## 7 Pin Trailer Harness Modifications for WH0207 and WH0212

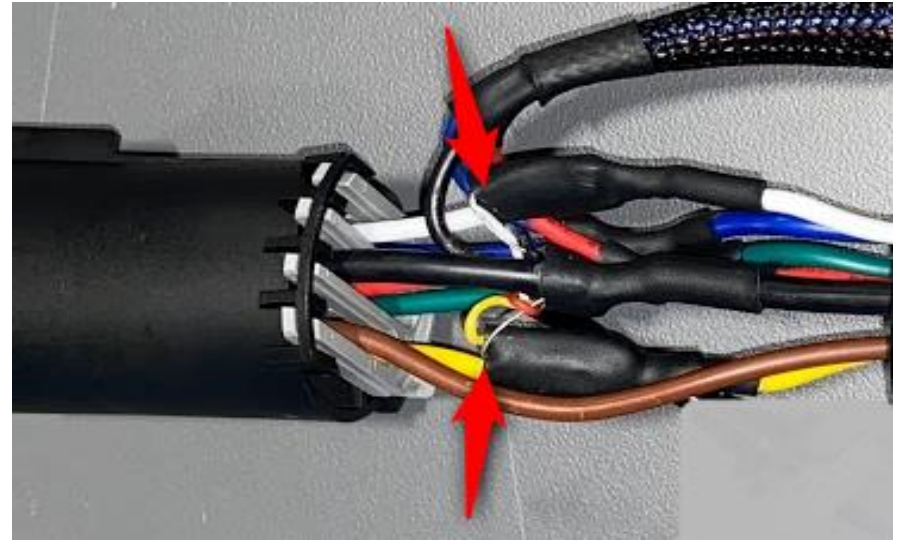
Unwrap Tesa tape from harness. Do not damage or discard tape because it will be re-used in a later step.

Locate the two metal leads from the inline resistors found on the white and yellow wires that attach to the black wire.

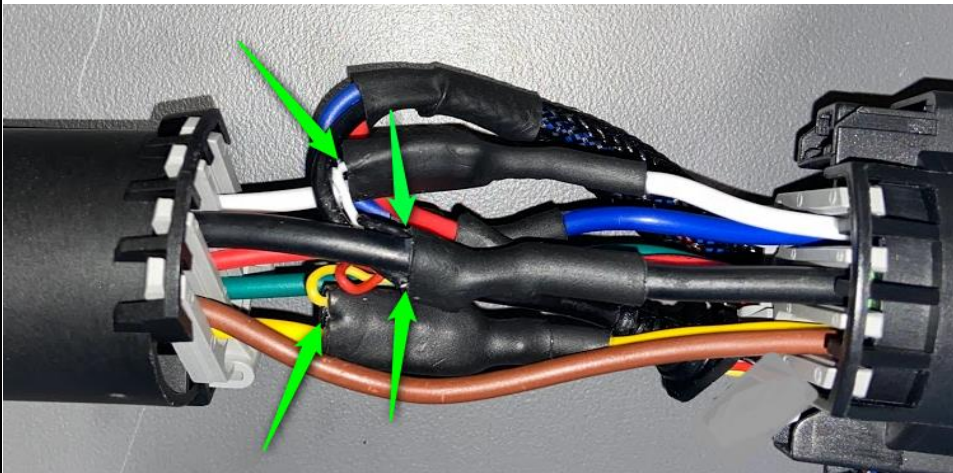
Cut the metal leads flush with the heat shrink at each attachment point so that nothing can come in contact with it. Be sure not to damage any wires in this process.
